ANALYSIS OF PUBLIC SUBMISSIONS

to the Draft Masterplan

Wedge and Grey

Department of Conservation and Land Management
for the
National Parks and Nature Conservation Authority
Perth, Western Australia, 2000

Figure 1.

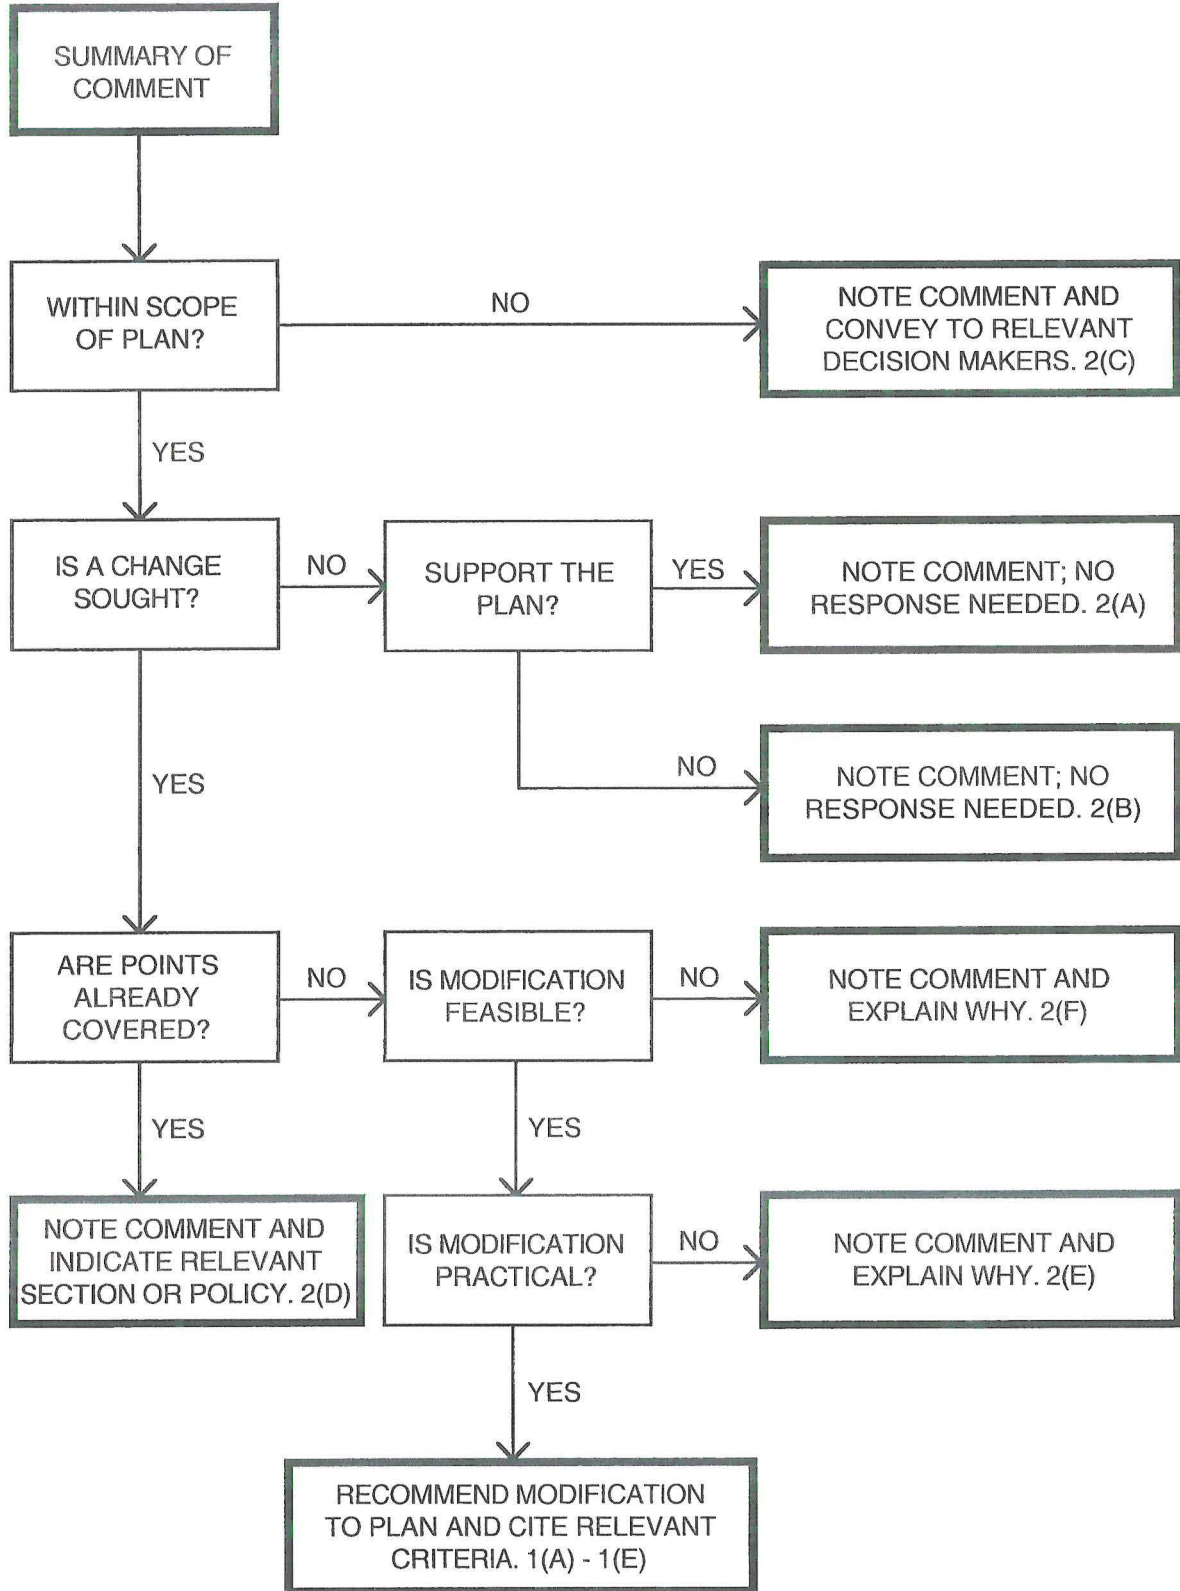
The public submissions to the Wedge and Grey Draft Masterplan were analysed according to the process depicted in Figure 1. More specifically:
